MFN 07-348

**Subject: Response to Portion of NRC Request for Additional Information Letter No. 85 Related to ESBWR Design Certification Application – RAI Numbers 21.6-96, 21.6-99 and 21.6-100**

**Response to Portion of NRC Request for  
Additional Information Letter No. 85  
Related to ESBWR Design Certification Application**

**RAI Numbers 21.6-96, 21.6-99, and 21.6-100**

Figure 21.6-96-1. DCD (Rev.3) Analysis: MSL Break Containment Case – Comparison of Drywell Pressures

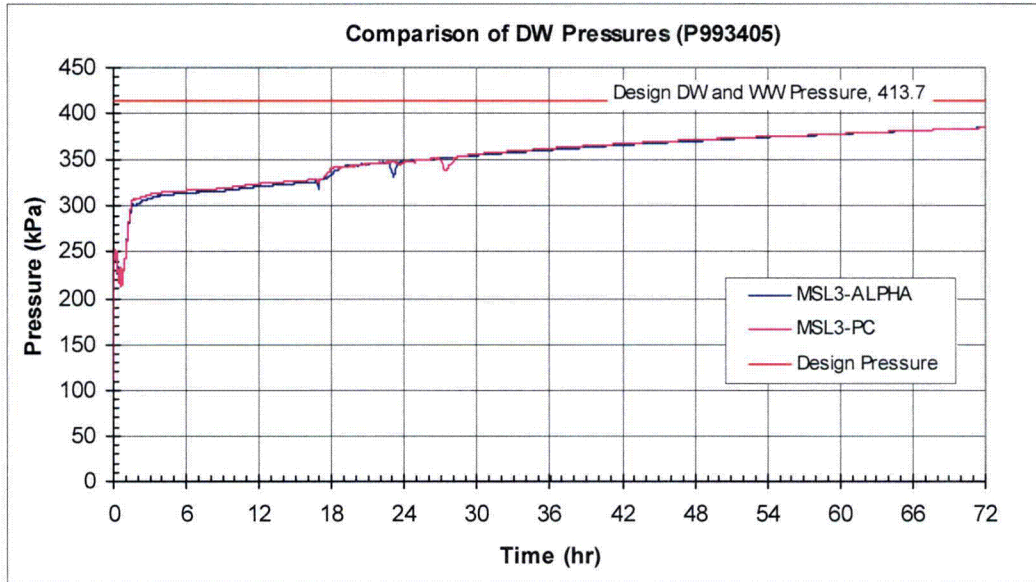
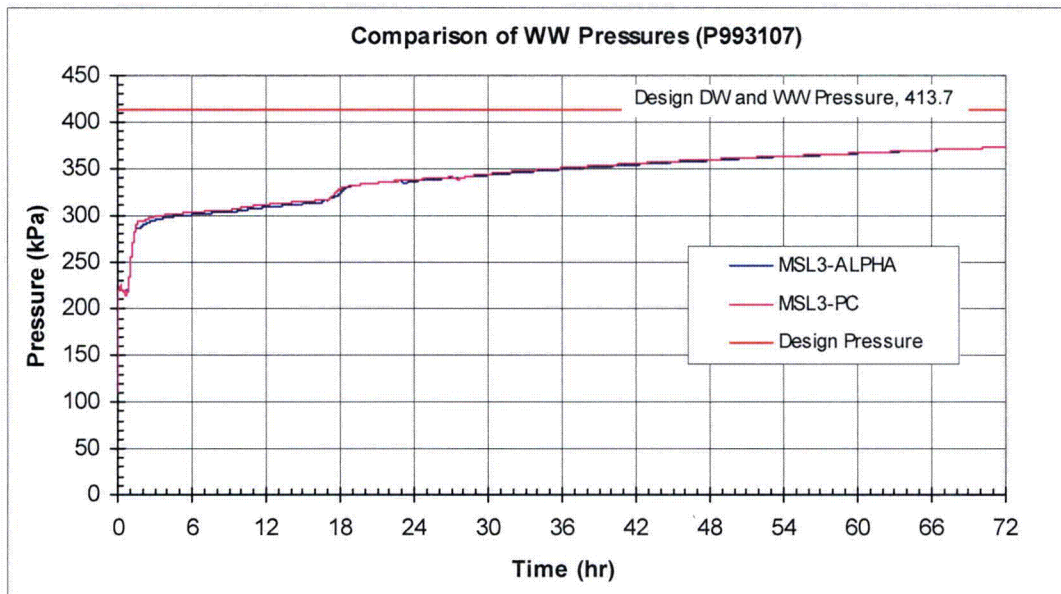
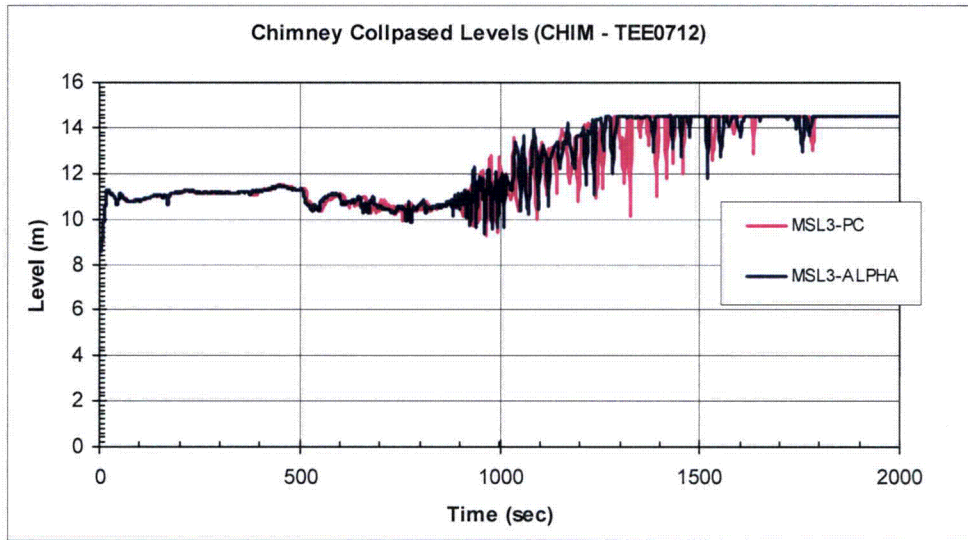
*B. The TRACG04A and P comparison that the staff viewed during the audit was for the limiting breaks in DCD Rev. 1, show the differences between TRACG04A and P for the limiting breaks in the most recent version of the DCD using the updated nodalizations.*

*C. The comparison between TRACG04A and P shows that TRACG04P predicts a long term drywell containment pressure lower by roughly 20kPa (or 3psi). For the DCD, Rev. 1 analyses the peak pressure was reached in the short term. For that calculation you stated -10-that the long term differences were not important for the peak pressure calculation. Rev. 2 of the DCD shows that peak pressure is reached in the long-term. Address the possible non-conservatism between TRACG04A and P for the long term peak pressure analysis in the latest revision of the DCD.*

*D. In your comparison between TRACG04A and P, you state that the reason for the difference in wetwell and drywell pressures was due to roundoff errors in non-condensable gas concentrations. The NRC staff is concerned that roundoff errors can have a substantial (roughly 7%) effect on calculated peak pressures. Address the concern that the TRACG04 and/or the ESBWR LOCA model may be hyper-sensitive to noncondensable gas concentrations.*

B. The differences between ALPHA and PC versions of the TRACG04 code for the limiting break in the DCD Tier 2 Revision 3 analysis are summarized in Table 21.6-96-1 and Figures 21.6-96-1 to 21.6-96-3.

- D. The differences in containment pressures between TRACG04 ALPHA and PC are mainly caused by mathematical accuracy differences between the two computer platforms and the ability of TRACG to accurately predict non-condensable gas distributions in general. The long-term peak pressure response is very sensitive to the amount of calculated non-condensable gas concentration remaining in the drywell. As such, small differences in input or numeric solution between the two codes can amplify containment pressure differences. In the DCD Tier 2 Revision 1 analysis, the drywell was not completely purged of non-condensable gas, thus causing long-term pressure differences to be in the order of 7%. A conservative approach to minimize the long-term pressure response sensitivity to non-condensable concentrations is to modify the input model nodalization to force all the air out of the drywell (see Response 21.6-96-C). This approach was applied in the DCD Tier 2 Rev. 3 analysis, reducing the long-term pressure differences between ALPHA and PC to < 1.0%, which is relatively small compared to the design limit margin of about 7% (413.7kPa). See Table 21.6-96-1 and Figures 21.6-96-1 to 21.6-96-3.
